**Appeal by Ministry of Justice
Land adjacent to HMP Garth and HMP
Wymott, Leyland Appeal Ref:
APP/D2320/W/22/3295556**

Updated Proof of Evidence of Kevin Riley

on behalf of Chorley Council

DRAWING No: 7769-WSP-SK-006
REV: P01

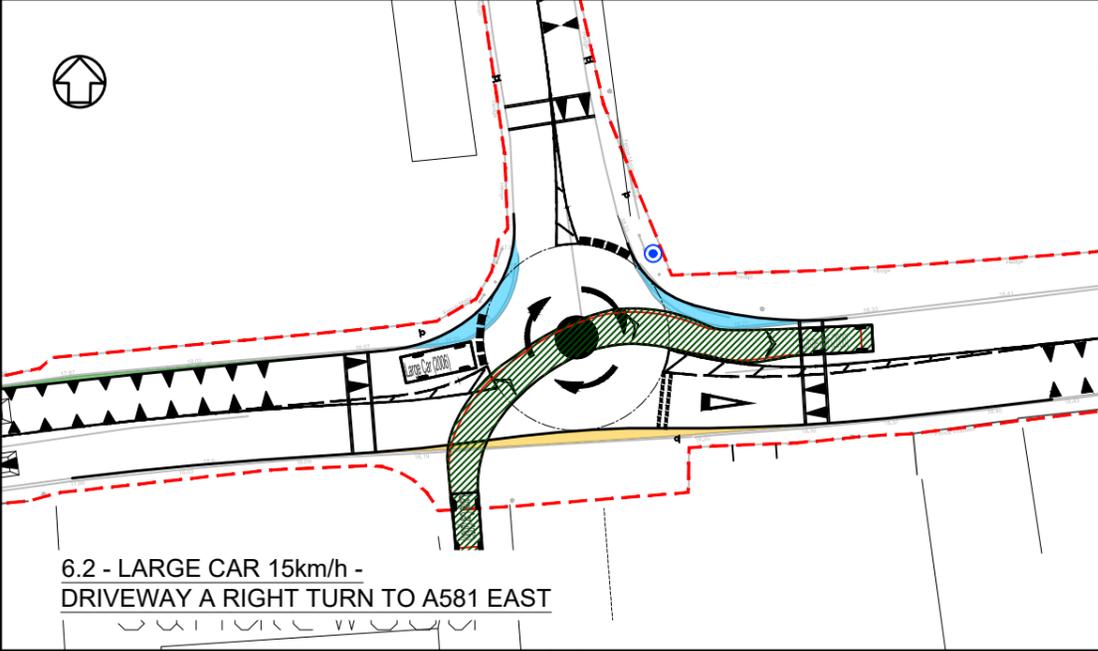
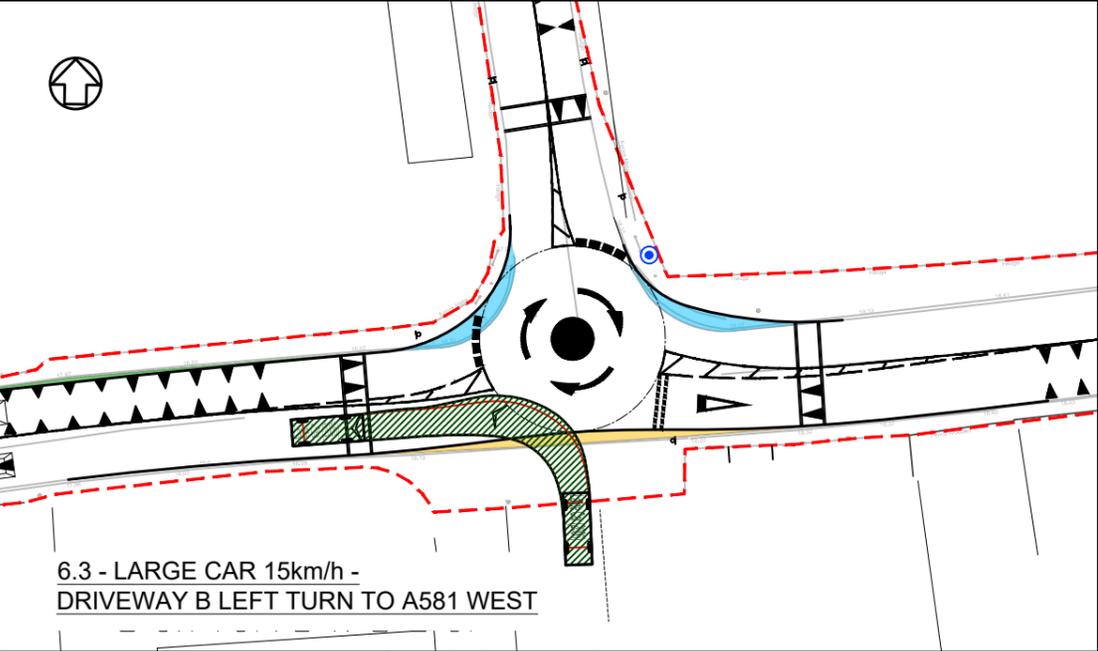
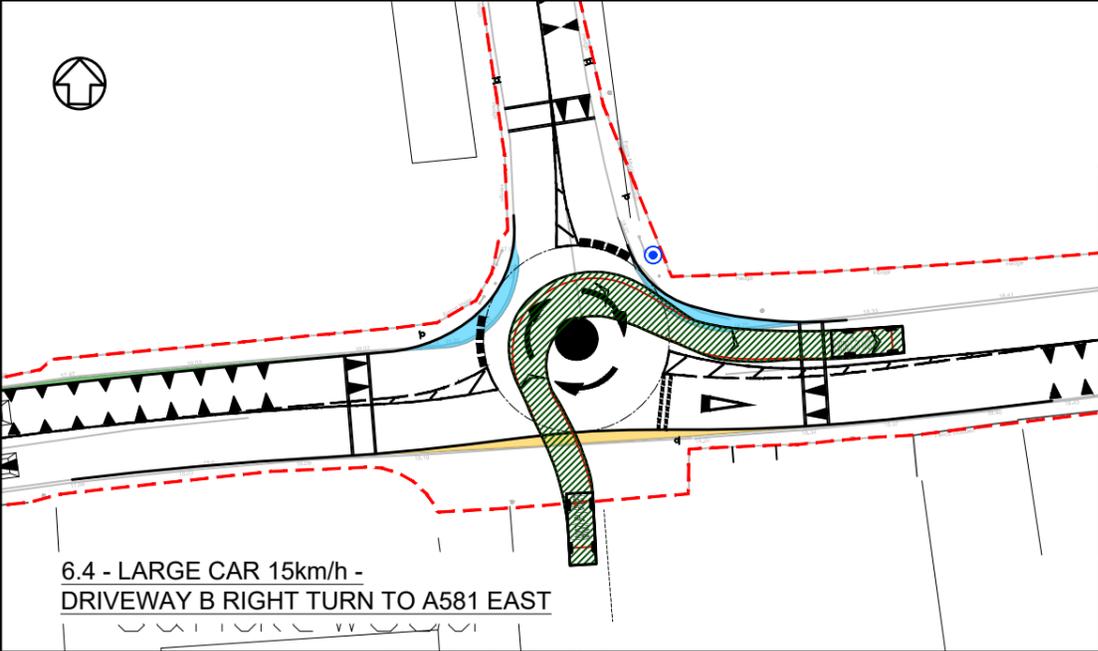
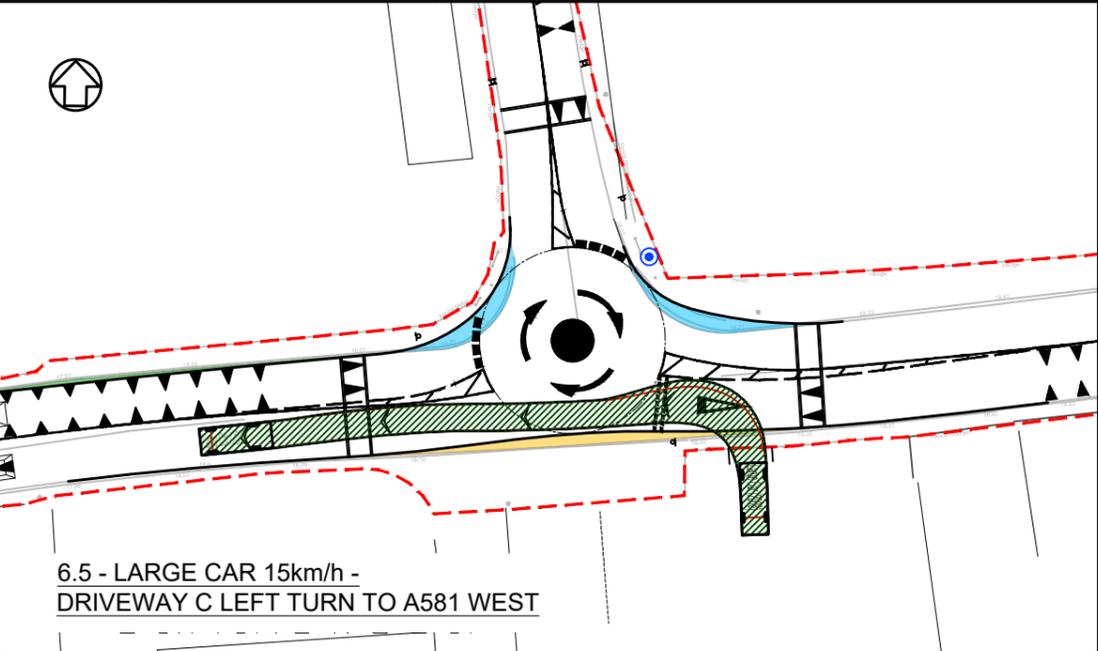
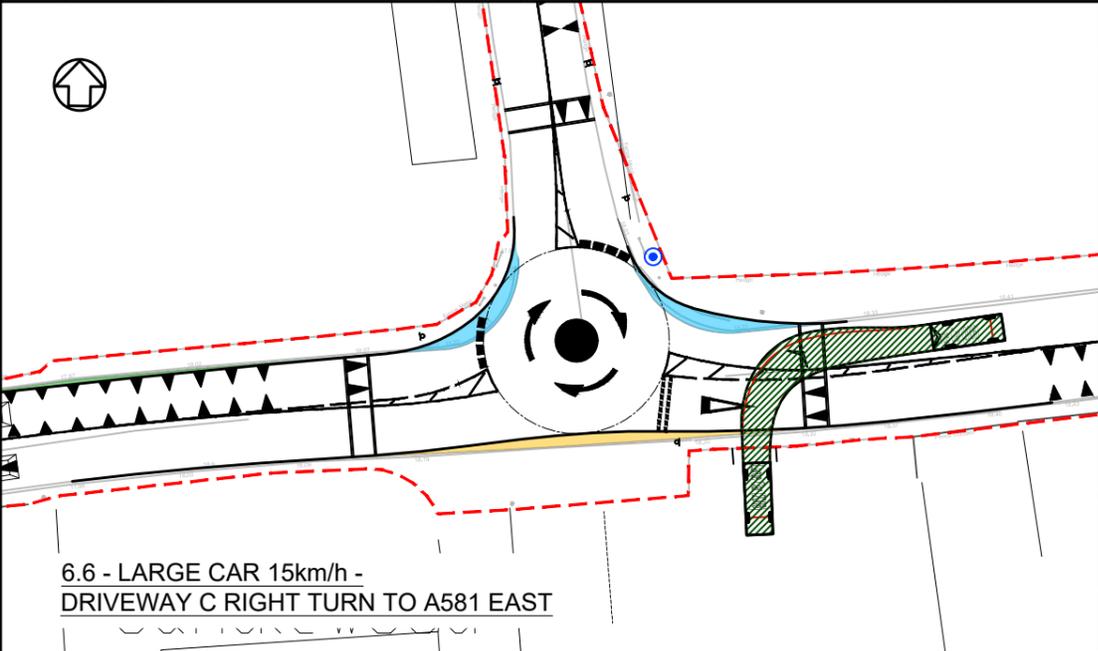
- 5.2.28 The Appellant has also supplied swept path analysis for a large car accessing the three driveways to the junction has not been demonstrated for every movement that could be made by those vehicles (this is the top row of plans at Appendix J). The vehicle tracking should, but fails to, demonstrate that a safe manoeuvre for left, right and ahead can be undertaken at the junction. Instead, the tracking demonstrates a single movement for each driveway.

- 5.2.30 The third swept path then appears to show a right-turning vehicle from the most western driveway needing to overrun the central road markings at the entry to the roundabout. This is a particularly unsafe manoeuvre that would lead to conflicts with vehicles approaching from the west on the A581.

- 5.2.31 Alternatively, as I have illustrated on 7769-WSP-SK-006 in Appendix A, drivers could be tempted to force their way out into traffic (plan 6.2) and potentially sit in the carriageway at 90 degrees to the flow of movements on the A581 waiting for a space to enter the roundabout (plan 6.6). Worse still, drivers could be tempted to cut through the centre of the roundabout. Both of which would be unsafe and increase the risk of accidents and neither are considered acceptable practice.
- 5.2.32 On this basis alone, I conclude that the proposed junction does not meet the necessary standard to mitigate the road safety impacts and this situation will be exacerbated by an increased number of vehicles generated by the proposals, particularly HGVs.
